# MEMORANDUM

SUBJECT: REZONING  
PLANNING & DEVELOPMENT SERVICES REPORT  
C9-14-03 Broadway Festival – Lenora Avenue R-3 to C-1 (Ward 6)

**PUBLIC FACILITIES AND SERVICES REPORT FOR JUNE 19, 2014**  
(as of May 27, 2014)

**C9-14 Broadway Festival – Lenora Avenue, R-3/C-1 to C-1**

**SITE PLAN**

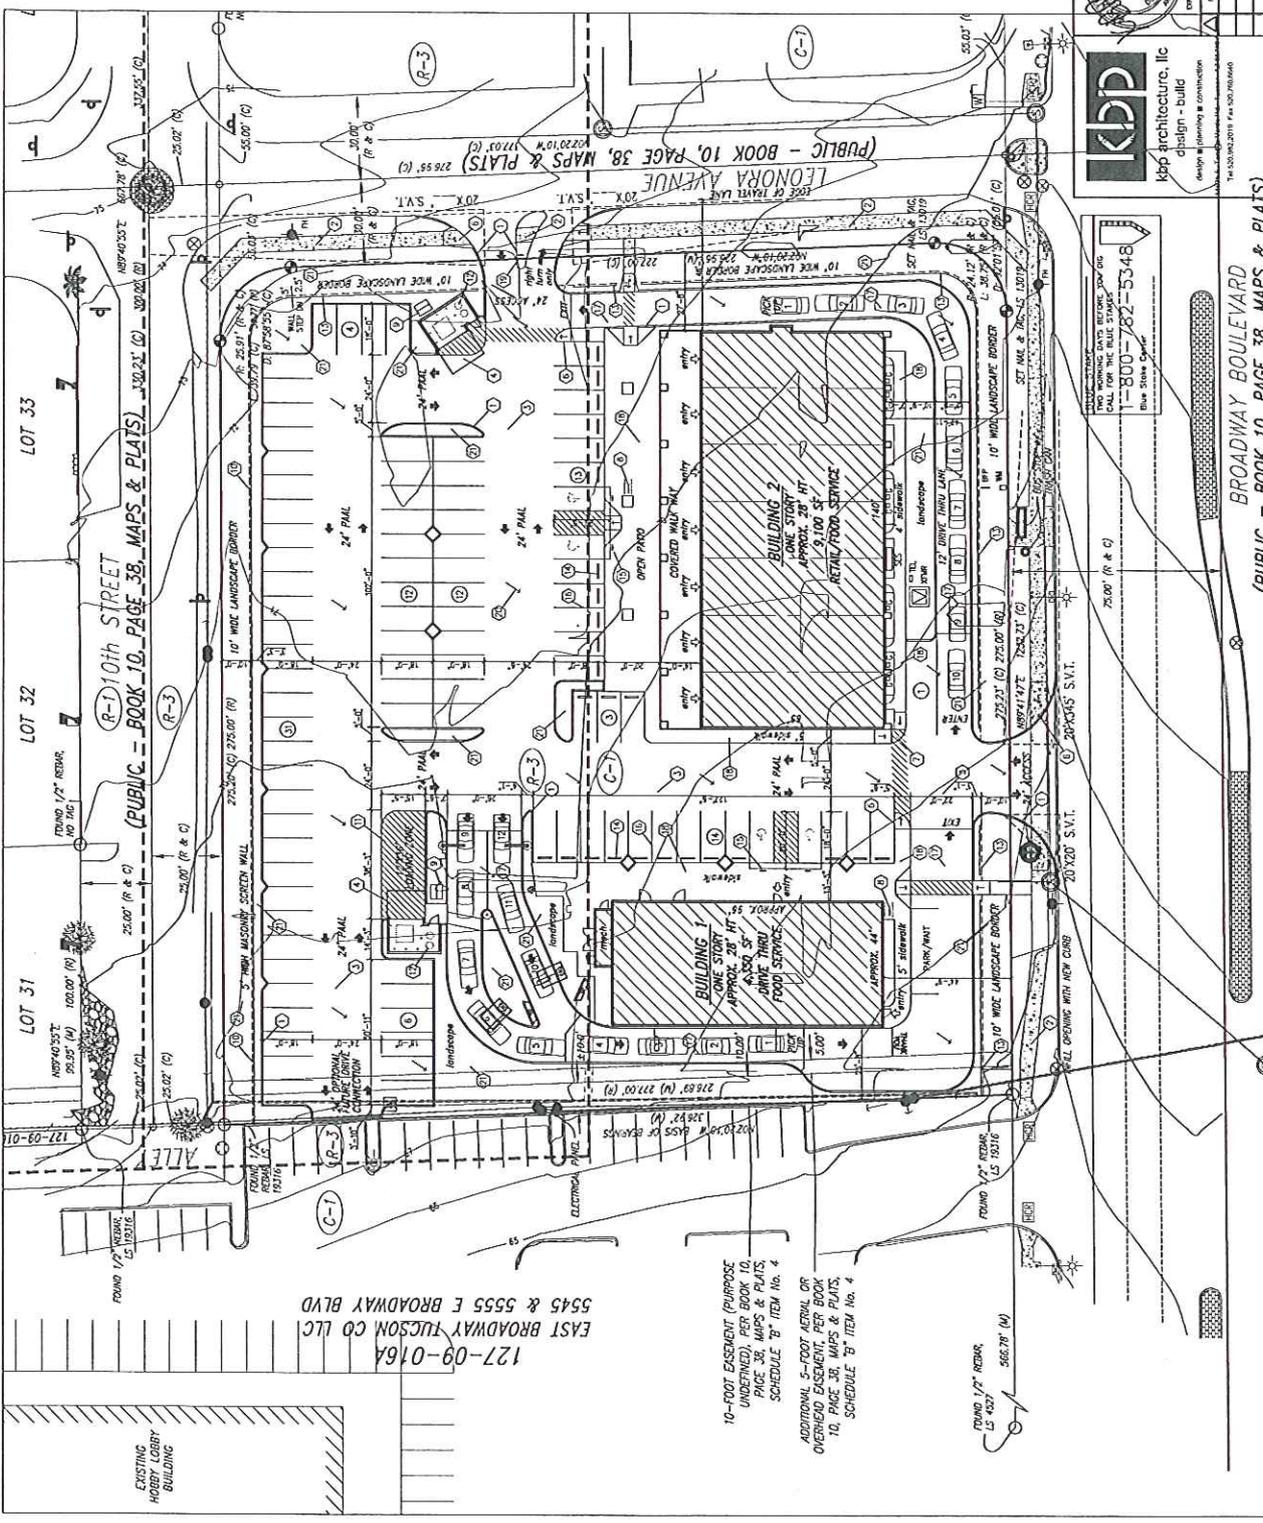
Another issue that needs further mitigation is that the on-site proposed improvements as shown on the PDP include commercial buildings at a height of twenty-eight (28') feet. At the time of the rezoning presubmittal meeting with planning staff and at the required neighborhood meeting, building height were presented at twenty-four (24) feet. Without the applicant conducting a second neighborhood meeting to discuss changes to their prior proposal, staff recommends a building height to reflect that presented to the neighborhood.

The DCR touches on the concept of proposed buildings being compatible with surrounding land uses and to be designed with four-sided architectural character and detail comparable to the front façade. However, neither the DCR nor PDP include detailed renderings or conceptual architectural drawings to show how the site design will address these issues. To address Plan policy, staff recommends architectural features and design elements be carried out at the same level of detail on all four-sides of the proposed buildings. It is recommended four-sided building elevations drawn to scale and in color be provided to show architectural design elements and color theme for the overall-site design. These conceptual drawings will also assist in addressing building mass and scale.

The proposed perimeter wall along the neighborhood edge is shown to be at five feet in height. However, at the neighborhood meeting held on February 24, 2014, Neighbors voiced a preference for a six foot tall masonry wall and asked about the color of wall, and preferred a higher density landscape buffer to reduce graffiti along the neighborhood perimeter. Plan policy related to compatibility with surrounding land uses can be partially addressed by providing street elevations of proposed improvements along those perimeters. Renderings drawn to scale, should include perimeter wall height, perimeter design and color, landscape material at maturity, access points, and the proposed building elevation(s) in the background.

Compatibility/Intensity. In general, the land use plan policies support C-1 commercial uses at the proposed rezoning site and surrounding properties fronting the Broadway commercial corridor. As proposed the site design is placing most of the commercial activities; buildings, drive-through lanes, outdoor patio area closer to Broadway and away from the residential edge located to the north. On-site circulation and integration with the adjacent commercial development should help improve business activity. Site circulation may also improve if drive-through lanes are designed to allow ample room for the stacking of vehicles in the drive-through lane without hindering on-site traffic circulation that may spill over onto off-site public street traffic flow. As designed, the drive-thru lane on the east building could create an off-site traffic issue at the Broadway access point. As proposed, the east building drive-through lane has its entrance/access point at approximately twelve (12) feet from the only entrance to the rezoning site from Broadway Boulevard. At peak hours, its possible stacking of this drive-through lane could extend out to Broadway right-of-way. Staff recommends drive-through lane entry point(s) be designed in mind with how the on-site traffic circulation may affect the overall site access onto public streets. Options

to consider would be to move the entry point of drive-through lanes at least fifty feet from any public street, or increase drive-through lane stacking to keep peak hour traffic within the drive-through lanes and not effect on-site PAAL's or public streets traffic flow. An option may be to redesign the east building drive-through lane to be double lane from entry point up to where the menu boards are to be located. Or move the drive-through entry point further north away from the Broadway Boulevard site entrance. This may require building footprint layout modifications to the east building.

The nearest residential unit is approximately one hundred and thirty (130) feet from the proposed commercial activities, this includes outdoor open patio area, drive-thru menu board and take out windows. If hours of operation extend into late hours, outdoor activities to exclude loud speakers, such as but not limited to; live music or DJ's, special events, car/motorcycle shows etc. Staff believes a site design addressing plan policy direction can create a neighborhood scale commercial site to be compatible with adjacent land uses.

**Comments:**  
The Preliminary Development Plan is acceptable; however a traffic study is required to adequately determine neighborhood impacts, and recommendations. A traffic count should be performed as a baseline for future reference.

**Comments:**  
Based on square footage, building 1 has an occupant load of 290 and building 2 (food service portion) has an occupant load of 200. A-2 occupancies with an occupant load of 100 or more require fire sprinklers. No fire service lines are indicated on the plans. Please resolve, clarify with information on DP plan.

8. No direct vehicular access permitted from rezoning site onto 10<sup>th</sup> Street.
9. The Lenora Avenue access shall restrict access to the north, as shown on PDP dated 4/23/14.

10. Outdoor activities, such as restaurant patios, speakers and music which may generate noise impacts to area residents located north shall be located a minimum of fifty (50) feet from the north property line.

14. A six (6') foot tall masonry wall with no less than six (6) inch wide masonry block material shall be located as part of the landscape buffer along the full length of the north perimeter adjacent to 10<sup>th</sup> Street, and that portion of the east perimeter landscape buffer located north of the Leonora Avenue access entrance.

21. A minimum of 13 stacking spaces shall be provided for each drive through window. Alternatively, drive-through lane(s) entry points shall be located a minimum of fifty (50) feet from public street access points.
